DESIGN REVIEW & PRESERVATION BOARD

LOCATION: 1215 - 19th Street

PROPOSAL: Rehabilitate firehouse (essential structure) into commercial office use.

PB 86-059

1215 19th St. (Circa 1900)

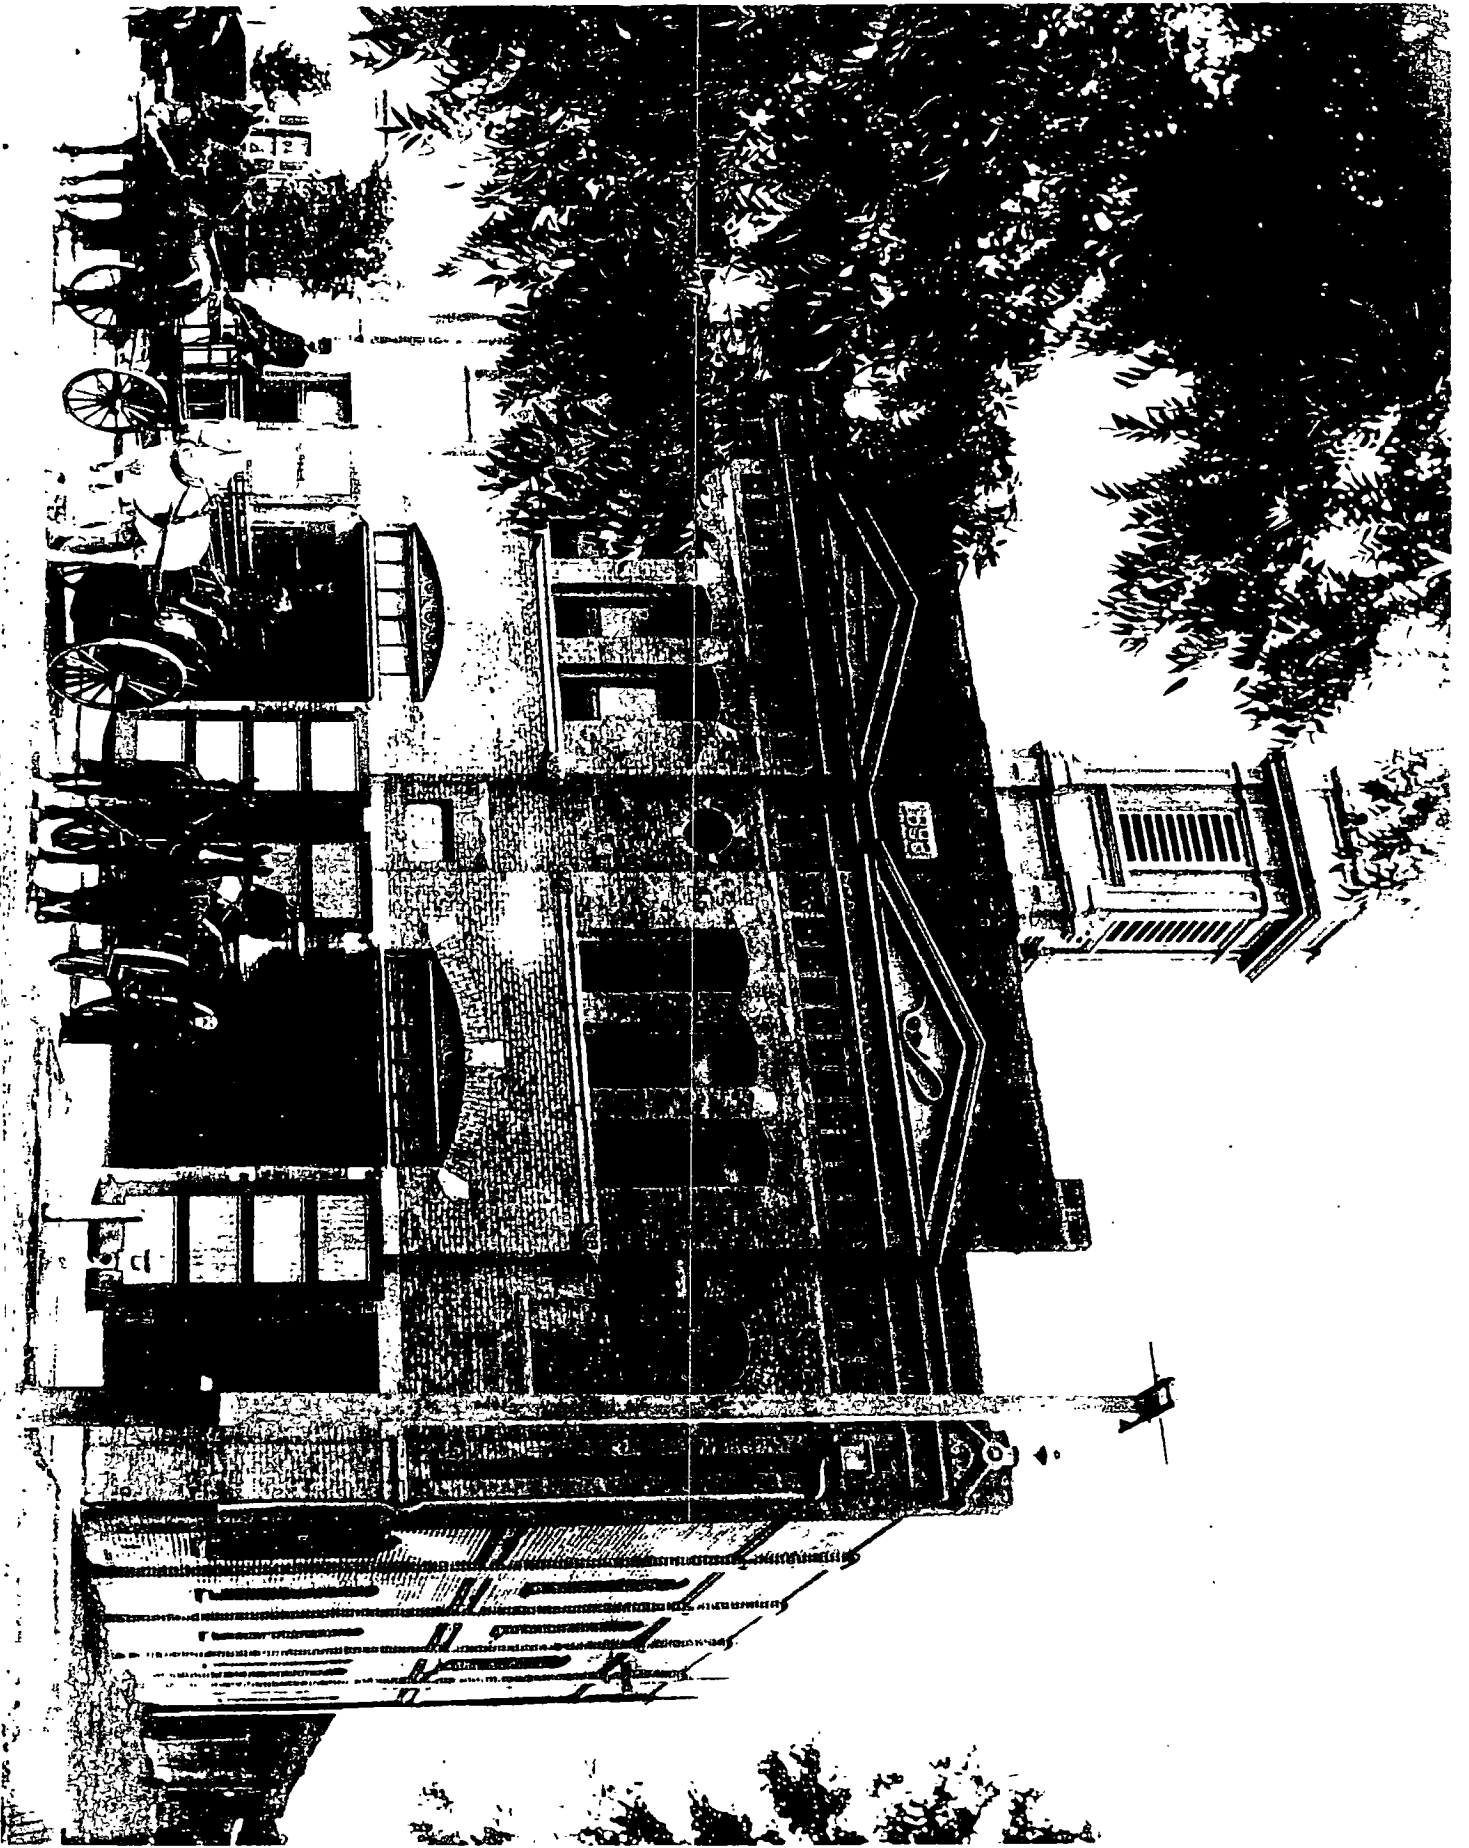
1. Return the structure to its original design character. Retain or replicate all decorative features as shown in the circa 1900 photograph. Cupola to be a Phase II project.

**WEST ELEVATION**

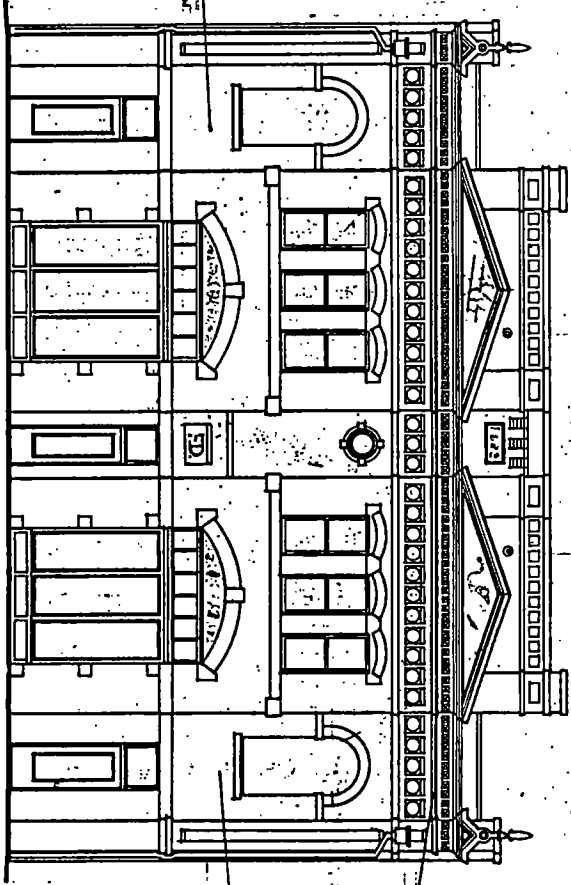
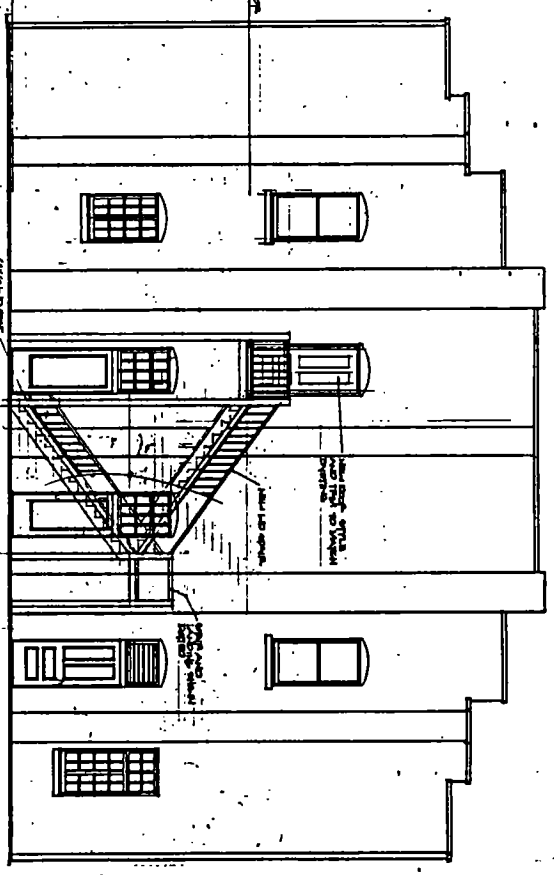
1. Rusticated stone used in the arches, some sills, a horizontal banding beneath the frieze area, between the tops of upper story windows, and other areas of the facade, should be given special attention from damage because they protrude. They are also an essential part of the facade design.

2. The facade includes areas that are of a lighter shade in contrast to the rest of the facade. This creates an interesting effect and should be retained. Some of these areas include the two gables with fireman symbols, the "1893" and "F.D." signs, rusticated stone areas, and other areas.

3. Returning the building to its original design includes replacing the four smaller wood doors. The two larger double doors should be replicated. They may retain their paneled look by replacing the central panels with glass for use as windows. The double doors may be fixed in place.

13. Provide two brick pads at building front to run from face of building to curb line to be width of double door openings.
14. Applicant to work with staff on smaller design details.

**SITE / LANDSCAPE PLAN**  
1/4" = 1'-0"

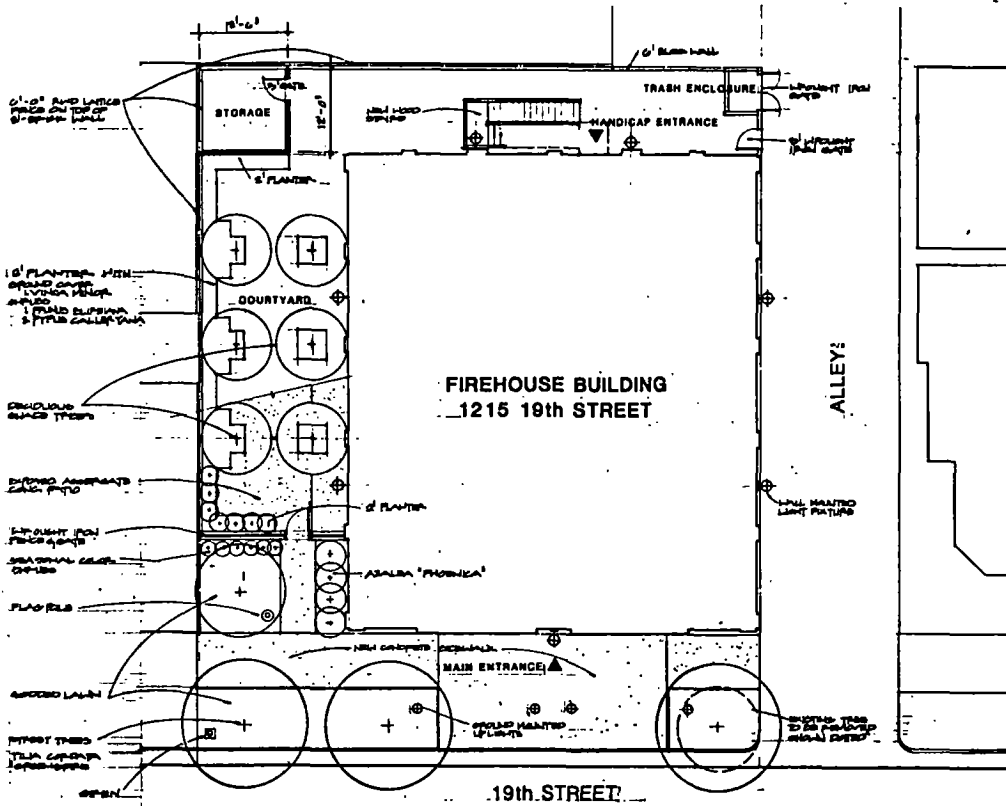
6. The applicant proposes to remove the Modesto Ash tree located on the park strip. Before removing the tree a landscape plan for the entire project should be submitted to staff for review and approval.

8. Retain second floor south wall door design or rebuild to be compatible with front door design.
9. Wrought iron gate on trash enclosure to be placed against a metal sheet to block visibility inside trash enclosure.

10. A second entrance to trash enclosure to be provided for easy access from building.
11. If the applicant wishes to exceed the six foot height to provide an eight foot fence on the north and east property line, a variance must be applied for through the Planning Commission.

12. If concrete block is to be used for the walls of the trash enclosure and the east wall at the property line, all block must be same material and the color must match the building color.

15. Final landscaping, shading and irrigation plans to be reviewed and approved at staff level.
16. Color and materials board to be submitted to staff for review and approval.

**SOUTH ELEVATION**

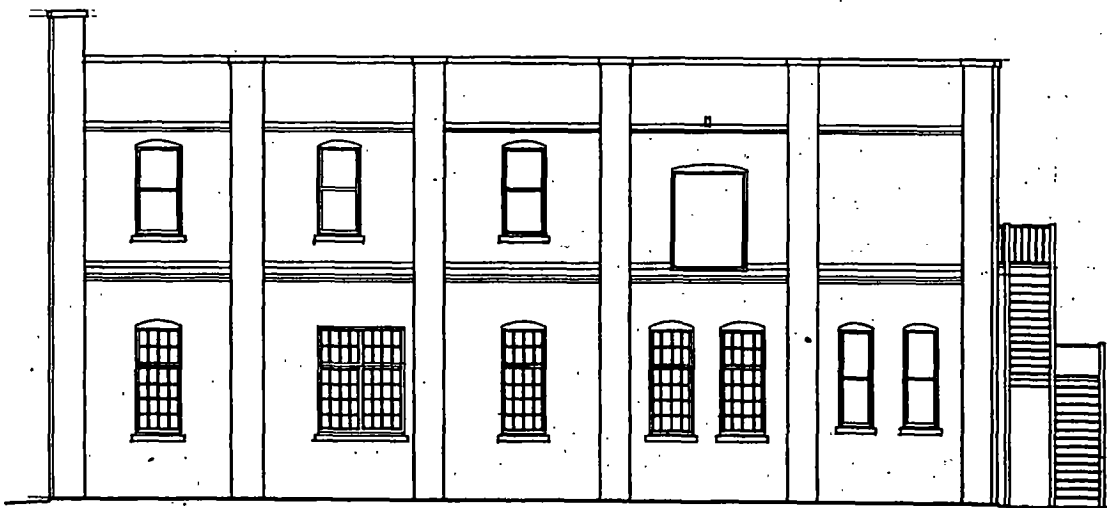
4. The second level doorway (on south elevation) can be closed off but the original design or a compatible design to the front doors should be provided.

17. Lifting hook above second floor door (south elevation) to remain.
